1807 W SUGAR CREEK RD

3046B/9417A

INDIVIDUAL WATER AND WASTEWATER SYSTEMS PROGRAM
APPLICATION FOR SERVICES

PROPOSED PLOT PLAN

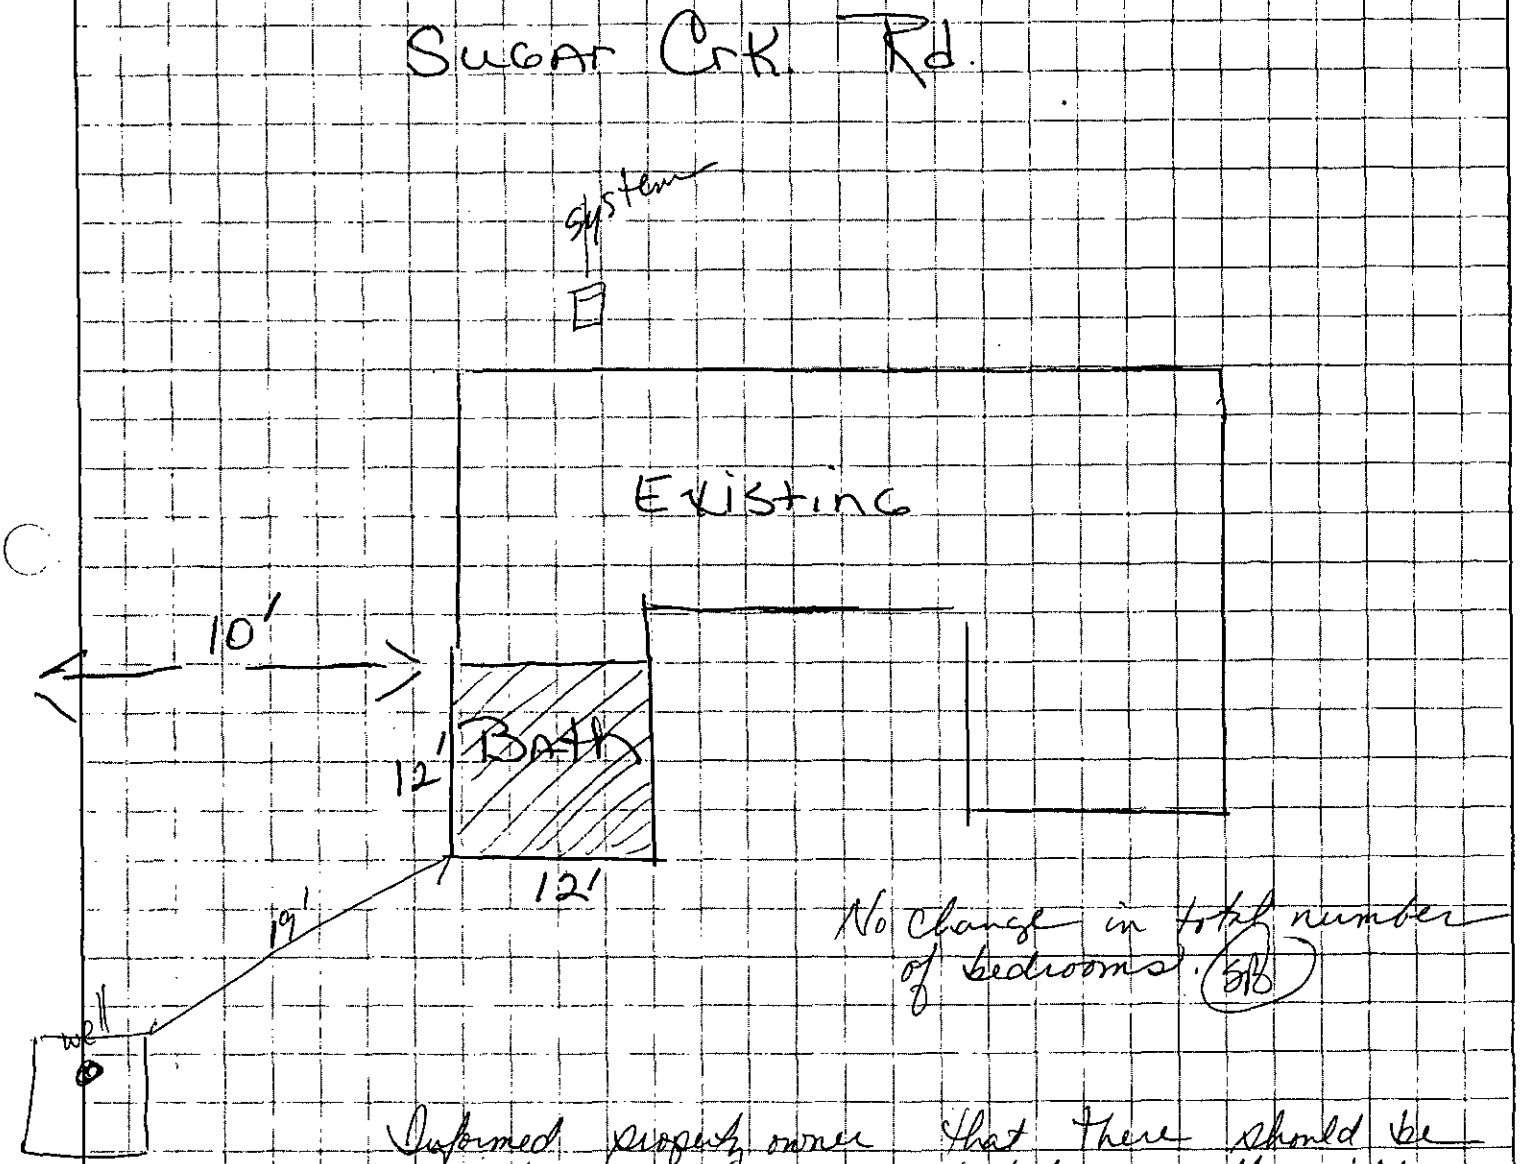
No change in total number of bedrooms. (5/8)

Informed property owner that there should be a separation distance of 25' between well & bldg foundation - Referred him to DEM in reference to this.

... use existing system - no change in the # of bedrooms. Keep proposed bldg foundation min 5' from any part of sewage treatment & disposal system.
